Final Safety Evaluation Report for Combined Licenses for Turkey Point Units 6 and 7

U. S. Nuclear Regulatory Commission
Office of New Reactors
Washington, DC 20555-0001

November 2016

This final safety evaluation report¹ (FSER) documents the U.S. Nuclear Regulatory Commission (NRC) staff's technical review of the combined license (COL) application submitted by the applicant for Turkey Point Units 6 and 7 by Florida Power & Light Company (FPL).

Figure 2.4.12-1. Simulated piezometric levels across the plant area (Layer 1-4 correspond to the four layers: Miami Limestone, Key Largo Limestone, Freshwater Limestone, and Fort Thompson Formation in the numerical model).

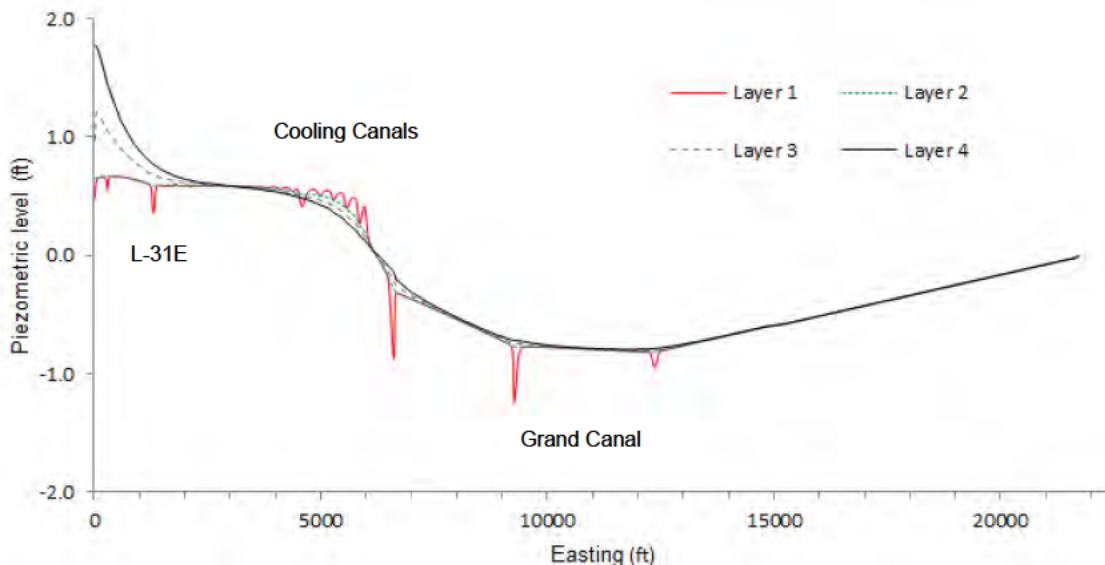
To assess the influence of water use in the plant on the regional groundwater flow directions, the staff took an east-west cross section from the applicant's 3-dimensional groundwater model grid (row 260, east-west across the plant) and constructed a 2-dimensional groundwater model using a publicly available spreadsheet tool (Anderson and Bair 2001). The boundary conditions in the east and west were modeled as fixed head boundaries. The results (Figure 2.4.12-1) confirm that the regional hydraulic gradient from the west (inland) to the east (ocean) is controlled by the water levels in the cooling and L-31E irrigation canals. The vertical gradient is even smaller and the variations near the canals are significant only in the first layer (Miami Limestone) and dampen out with depth in the underlying layers 2–4 (Key Largo Limestone, freshwater limestone, and Fort Thompson Formation, respectively). These results show that as long as the water level in the canals is maintained at the designed level, water use at the plant is not expected to alter the regional groundwater flow direction (from the west to the east, and from underground to the ground surface). This is due to the relatively permeable subsurface geologic formations and small hydraulic gradient at the site.

The staff performed an independent confirmatory analysis of the potential impact of the maximum water level of 22.5 ft (6.9 m) in the MWR on the subsurface potentiometric head distribution at Turkey Point Units 6 and 7, as described below. The staff calculated the lateral head losses from the MWR through the 3 ft (0.9 m) thick concrete floor and then through 100 ft of the Miami Limestone aquifer. According to Darcy's law, discharge rate, q , is estimated as $q = k_1 \Delta h_1 / L_1 = k_2 \Delta h_2 / L_2$, and $\Delta h = \Delta h_1 + \Delta h_2$, where k , Δh , and L are the hydraulic conductivity, head loss, and length, and subscripts 1 and 2 stand for the concrete layer and aquifer layer, respectively. It can be derived that $\Delta h_1 / \Delta h = (L_1 / k_1) / (L_1 / k_1 + L_2 / k_2)$. Using conservative values for k_1 and k_2 , i.e., $k_1 = 10^{-8}$ cm/s (Turkey Point Units 6 and 7 COL FSAR 2.4.13.1.3.1 assumes 8.25×10^{-9} cm/s, which is an order of magnitude higher than that of intact concrete in included reference) and $k_2 = 10^{-4}$ cm/s (less than the smallest calibrated value in Turkey Point Units 6 and 7 COL FSAR Table 2CC-205), the calculated head loss in the concrete floor is 22.4 ft (6.8 m). This result indicates that most of the head is expected to be lost over the concrete floor of the MWR due to its low permeability. Therefore, the water in the MWR, even at maximum level, is not expected to raise the groundwater table under Turkey Point Units 6 and 7 significantly (less than a few feet, comparing with the 23.5 ft (7.2 m) design elevation). Accordingly, the staff's review of the studies and reports described above and the staff's evaluation of the applicant's analysis described above confirmed that the applicant's description of the groundwater flow directions is acceptable and adequate.

Figure 2.4.12-2. Maximum groundwater mounding under steady-state flow condition with aquifer thickness of 25 ft (7.6 m) (freshwater limestone as the aquitard).

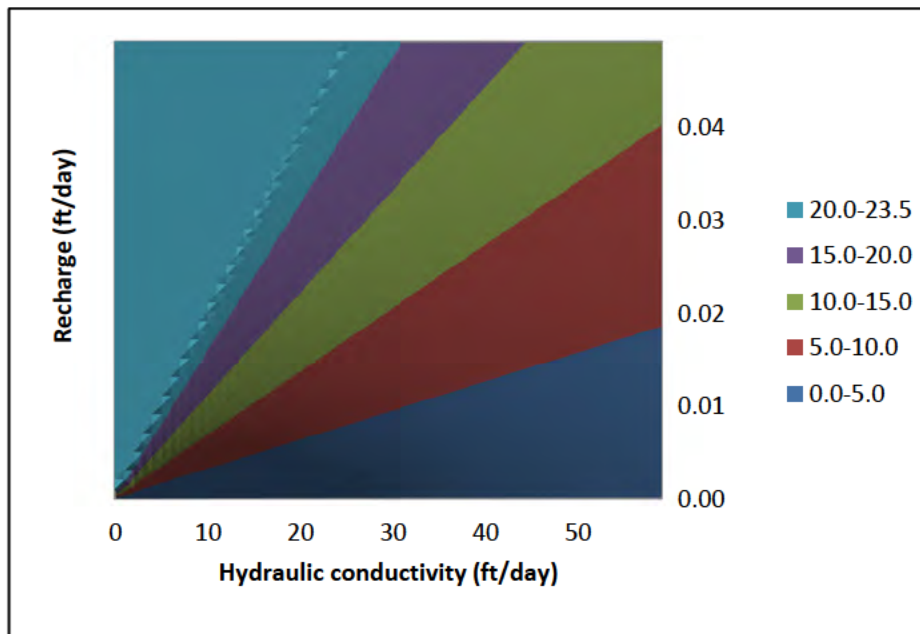
Let $R = 1,330$ ft (405 m), and h_{max} is dependent on the hydraulic conductivity, recharge rate, and aquifer thickness. A hydraulic conductivity of less than 3-4 ft/day (0.9-1.2 m/day) is necessary for the mounding to be over the 23.5 ft (7.2 m) maximum groundwater level (Figure 2.4.12-2) with a recharge equal to the annual precipitation $w = 3.79$ ft/year = 0.01 ft/day and an assumed aquifer thickness of 25 ft (freshwater limestone as the aquitard). As the vertical hydraulic conductivity of the surficial Biscayne aquifer is approximately 15 ft/day (4.6 m/day) (Turkey Point Units 6 and 7

COL FSAR Revision 2, Table 2.4.12-205), the maximum water level is not likely to be exceeded under steady-state flow conditions, given expected conductivity of the fill material used to build up the island. Accordingly, the staff finds that that the maximum groundwater level meets the criteria of the Design Control Document (DCD) of the AP1000 at a maximum of 2 ft (0.6 m) below grade.

Figure 2.4.12-3. Groundwater mounding calculated using Basak (1982) for the 72-hour probable maximum precipitation of 55.7 in.

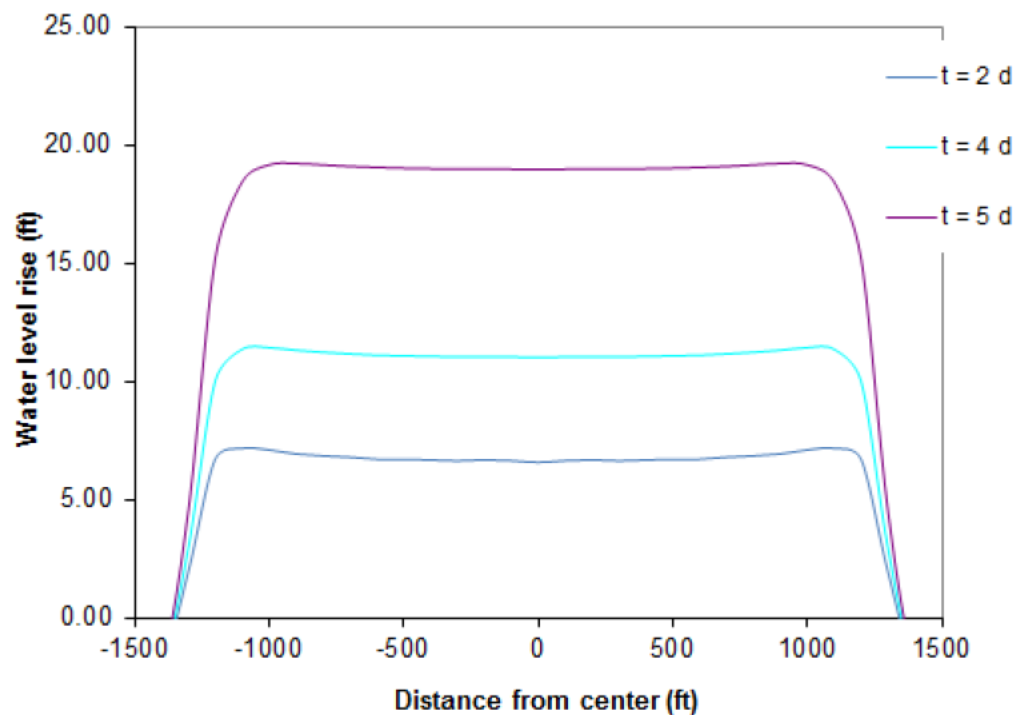
The staff also estimated maximum groundwater elevation under a transient flow scenario. The 72-hour probable maximum precipitation of 55.7 in. for areas of 10 mi² or less in the Florida peninsula was considered. The approximate analytical solution by Basak (1982) was used to calculate the groundwater table mounding. The results (Figure 2.4.12-3) show that the maximum water level of 23.5 ft (7.2 m) is not likely to be exceeded, even when the maximum precipitation occurs for 5 days ($R = 1,330$ ft (405 m), $k = 15$ ft/day (4.6 ft/day), $b_0 = 50$ ft (15.2 m), and specific yield = 0.3). Even though the Basak (1982) solution is accurate only for a small mounding level (say 5 ft (1.5 m) of a 25 ft (7.6 m) thick unconfined island aquifer) and for a hydraulic conductivity greater than the recharge rate, the possible maximum mounding level would be expected to be much less than 23.5 ft (7.2 m) for an expected recharge rate less than 1 ft/day, and hydraulic conductivity greater than 10 ft/day (Figure 2.4.12-4). Accordingly, the staff finds that that the maximum groundwater level under a transient flow scenario meets the criteria of the Design Control Document (DCD) of the AP1000 at a maximum of 2 ft (0.6 m) below grade.

design level. In the staff's analysis, no coverage of ground surface with pavement was assumed. The results of the staff analysis confirmed that the extent of pavement did not influence groundwater mounding

Figure 2.5.1-10. Strike-slip fault (unnamed) in Biscayne Bay (Source: Turkey Point Units 6 and 7 FSAR Figure 2.5.1-393, Cunningham et al., 2012 and Cunningham, 2015).

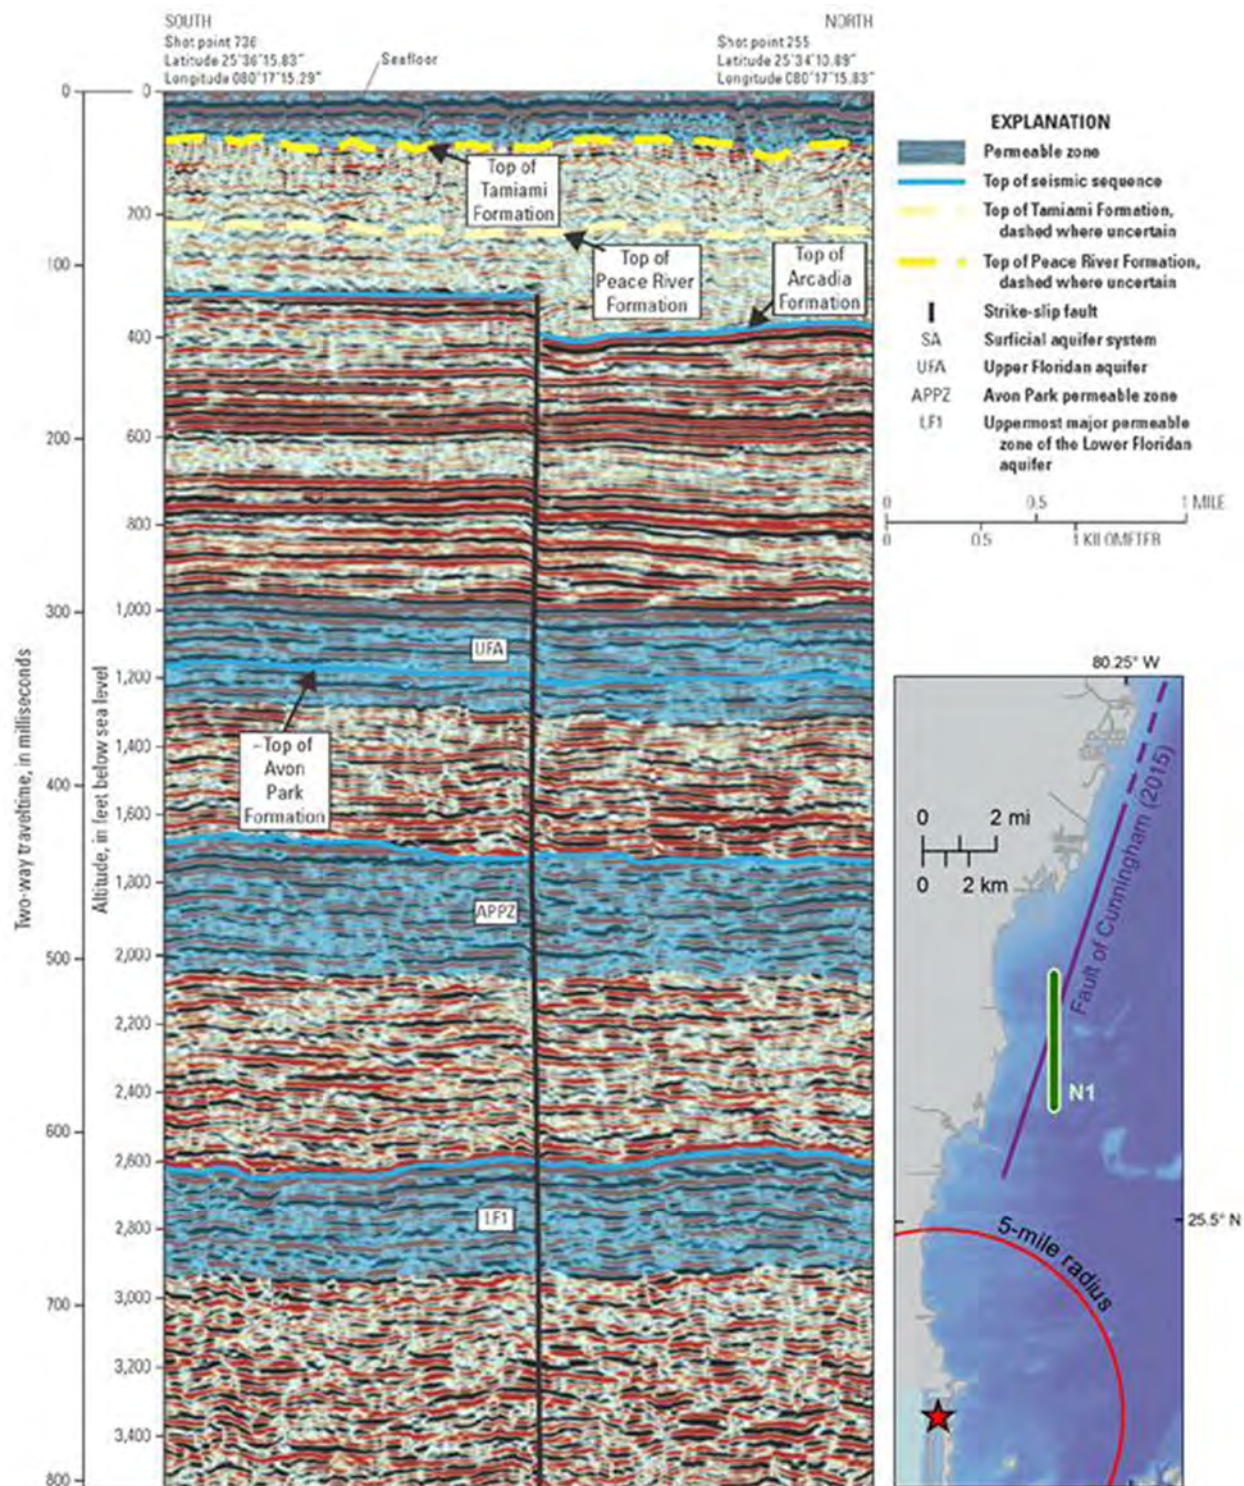
The staff independently sought out and reviewed many publications pertaining to the Turkey Point Units 6 and 7 COL FSAR review and found a recent short paper (Cunningham et al., 2012) that reveals normal and reverse faults in Biscayne Bay and the shelf margin, within 11.3 km (7 mi) of the site, based on approximately 210 km (130 mi) of high-resolution marine seismic data. One of these faults is identified on 5 seismic lines and extends about 16 km (10 mi), striking N, NE (Figure 2.5.1-10). The authors interpret this fault as a vertical normal fault offsetting the top of the Arcadia Formation. The staff notes that the fault projects directly toward the Turkey Point Units 6 and 7 site. Because the fault appears to offset the top of the Arcadia Formation, the age of movement might be as young as early Pliocene (5.3 Ma). The staff also notes that this tectonic structure is not included in the Turkey Point Units 6 and 7 COL FSAR. In RAI 81, Question 02.05.01-36, the staff asked the applicant to discuss this tectonic feature with respect to the Turkey Point Units 6 and 7 site, and integrate the information into the regional tectonic setting. The staff also asked the applicant to address the possibility that the fault is strike-slip and finally to address the possibility that this fault underlies the Turkey Point Units 6 and 7 site, and what impact if any does this have on potential surface deformation.

In a May 19, 2015, response to RAI 81, Question 02.05.01-36 (ADAMS Accession No. ML15156A616), the applicant cited a recent USGS Scientific Investigations Report (Cunningham, 2015) that includes additional information about the fault identified in Biscayne Bay. Cunningham (2015) extends the fault, as uncertain, an additional 30 km (20 mi) northward through a data gap to connect with a possible offset identified in seismic profiles at the Miami-Dade North District Boulder Zone Water Field. Cunningham (2015) now interprets this fault as strike-slip with a characteristic normal, dip-slip component (up to the east), with typically about 12 m (40 ft) of vertical separation. The youngest faulted strata are the Arcadia Formation (Miocene age). The author interprets the top of Peace River and Tamiami formation (Pliocene) strata as unfaulted. Movement on the fault is thus interpreted to be within mid Miocene to early Pliocene, meaning no movement in the last 3.6 Ma.

Figure 2.5.1-11. Miami Terrace anticline from Cunningham, 2015 (Source: Turkey Point Units 6 and 7 COL FSAR Figure 2.5.1-395)

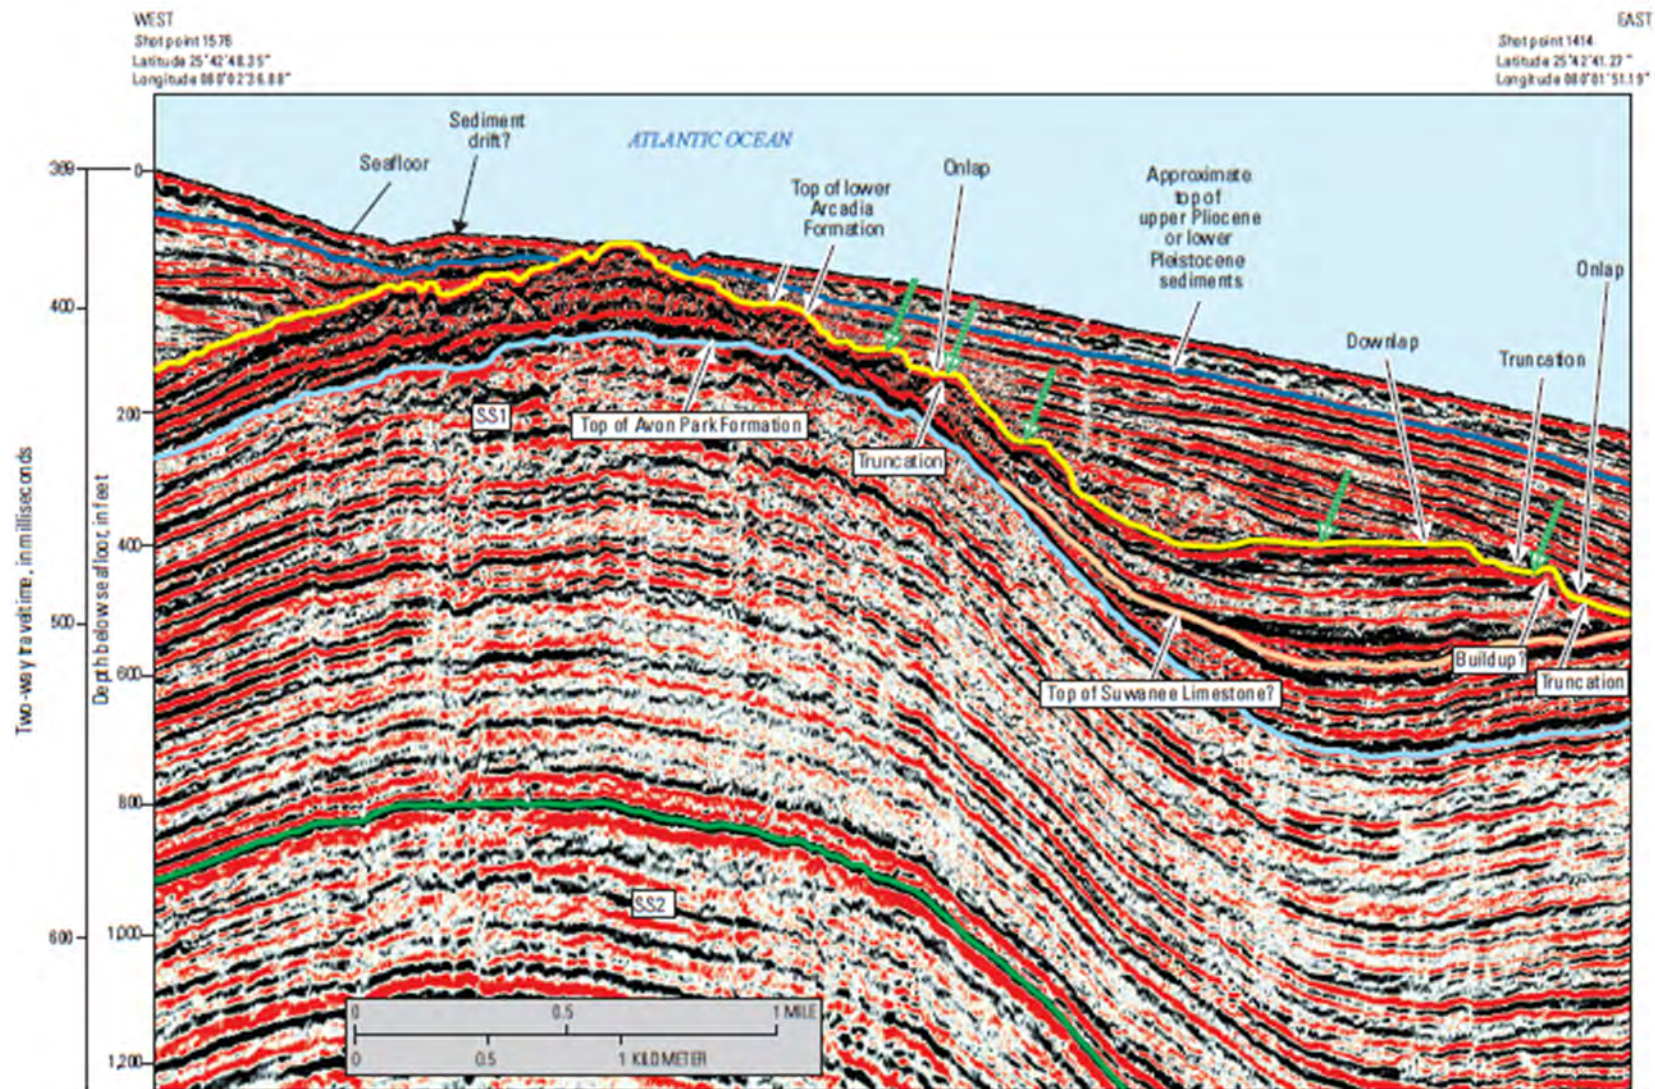
The staff independently reviewed Cunningham (2015) and observed a tectonic anticline, located east of Miami, on the Miami Terrace, about 48.2 km (30 mi) from the Turkey Point Units 6 and 7 site that has not been previously discussed in the Turkey Point Units 6 and 7 COL FSAR. Cunningham (2015) clearly shows a tectonic anticline with uplifted truncated seismic reflections assigned to the top of the lower Arcadia Formation (Figure 2.5.1-11). Horizontal, buried wave-cut terraces on the flank of the anticline indicate uplift and erosion of the lower Arcadia Formation followed by deposition of late Pliocene or early Pleistocene-age sediments. The author suggests that this compression event is consistent with the timing of tectonic movement of the Santaren anticline, also considered a potential Quaternary structure. The staff also notes that this young tectonic structure is close to the Turkey Point Units 6 and 7 site and has not been previously characterized in the Turkey Point Units 6 and 7 COL FSAR. Therefore, in RAI 85, Question 02.05.01-38, the staff asked the applicant to discuss this tectonic feature with respect to the Turkey Point Units 6 and 7 site, to integrate the feature into the regional tectonic setting for the Turkey Point Units 6 and 7 site COLA, and, finally, to discuss how this feature might affect the PSHA at the Turkey Point Units 6 and 7 site in light of sensitivity analyses completed for the Santaren Anticline and the Walker's Cay fault, 274 and 320 km (170 and 200 mi) from the Turkey Point Units 6 and 7 site, respectively.

In addressing the staff's question regarding the Miami Terrace structures' effect on the Turkey Point Units 6 and 7 site's PSHA (RAI 85, Question 02.05.01-38), the applicant cited Appendix A to RG 1.208 definition of a capable tectonic source and stated that because the uppermost deformed strata observed in the anticline and reverse faults is the Oligocene to Miocene Arcadia Formation, the structures are not considered to be capable tectonic features. The applicant pointed out that there is only one Emb 2.70 earthquake in the project Phase 1 earthquake catalog, including dependent events, located approximately 10 km away from the Miami terrace structures. Thus, there does not appear to be an association of seismicity with these structures. Therefore, the applicant stated that the reverse faults and fold reported by Cunningham et al. (2012) and Cunningham (2015) are not capable tectonic sources and would not affect, and should not be included in, the PSHA for the Turkey Point Units 6 and 7 site.

Figure 2.5.1-13. Profile 20 as interpreted from Kula, 2014.

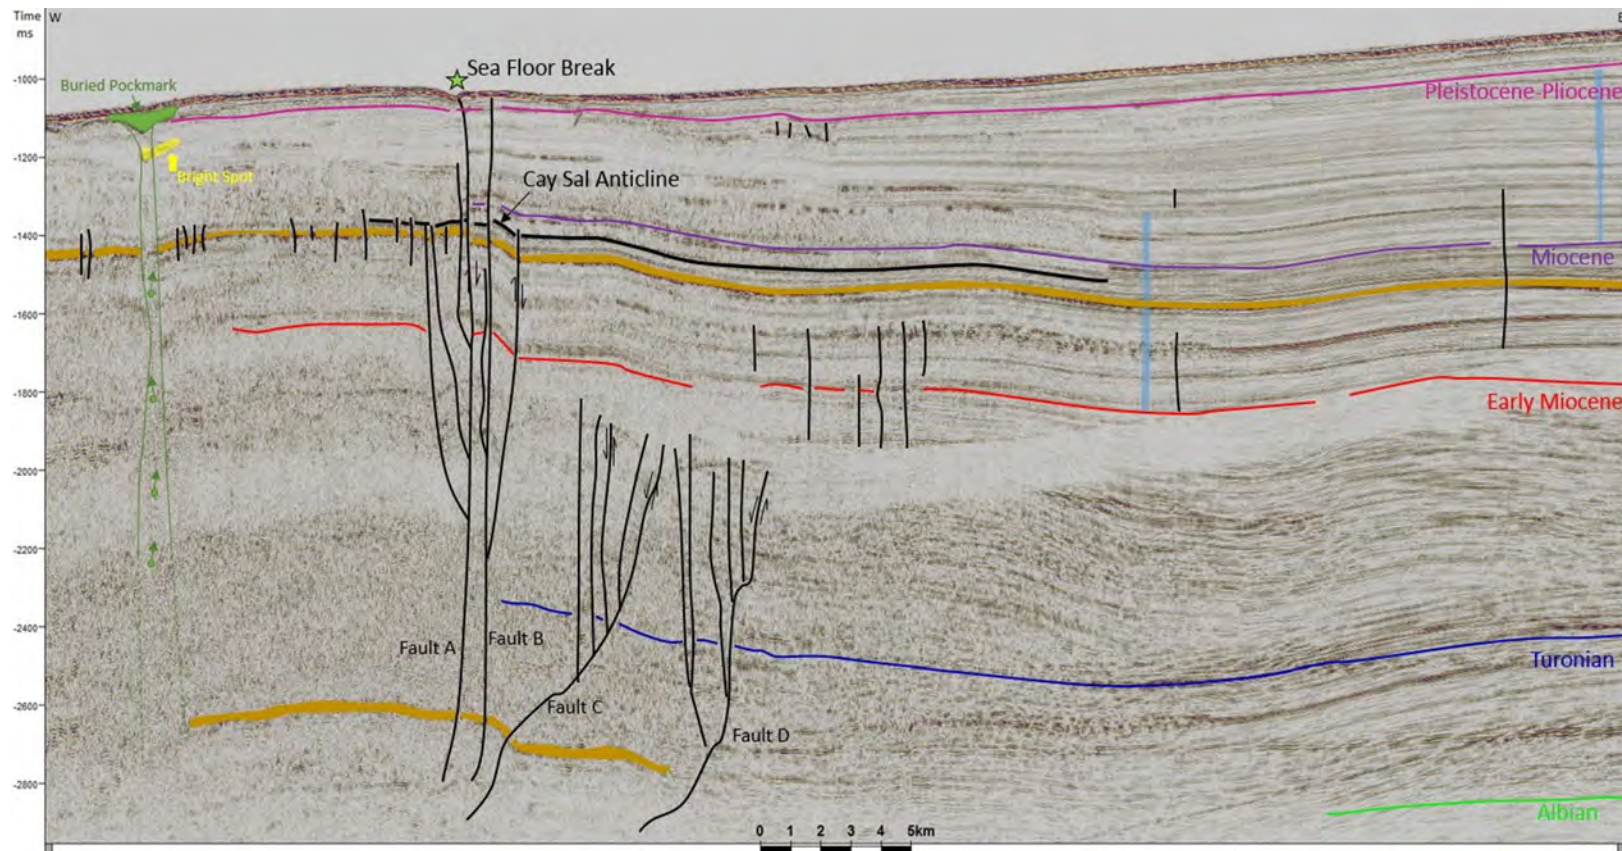
The staff reviewed Kula (2014) and notes that the author includes interpretations regarding possible Quaternary tectonic faults along the western bank of the northern Santaren Channel (northeast of the Cay Sal Bank). High resolution seismic reflection, multibeam bathymetry and sub-bottom parasound profiles reveal Quaternary-aged tectonic structures in the Santaren Channel and the Straits of Florida within about 50 mi of the Turkey Point Units 6 and 7 site (Figure 2.5.1-13). Although there is no seismicity in the area beneath Cay Sal Bank and the Santaren Channel, distinct seafloor scarps suggest recent and significant displacement on faults imaged on seismic reflection. In RAI 81, Question 02.05.01-34, the staff asked the applicant to discuss and integrate these tectonic features into the regional tectonic setting for the Turkey Point Units 6 and 7 site. The staff asked the applicant to provide an analysis of how a northward extension of the Cuban Fold and Thrust Belt terrane with associated Quaternary fault displacement and seafloor scarps on at least two faults impacts the site seismic hazard assessment and seismotectonic boundaries. The staff also asked the applicant to update interpretations of the Santaren Anticline

Based upon all the material that the staff reviewed related to this question, the staff decided to conduct its own seismic hazard sensitivity analysis. The applicant provided a synopsis of Kula's (2014) interpretation of four tectonic faults along the eastern margin of Cay Sal Bank, and her interpretation that these faults represent an extension of the Cuba Fold and Thrust Belt a few hundred kilometers farther north and east than previously mapped by others. Kula suggests neotectonic activity on two of these faults (Fault A and B) along the eastern margin of Cay Sal Bank and north to the Straits of Florida. Kula (2014) interprets that the faults extend in length
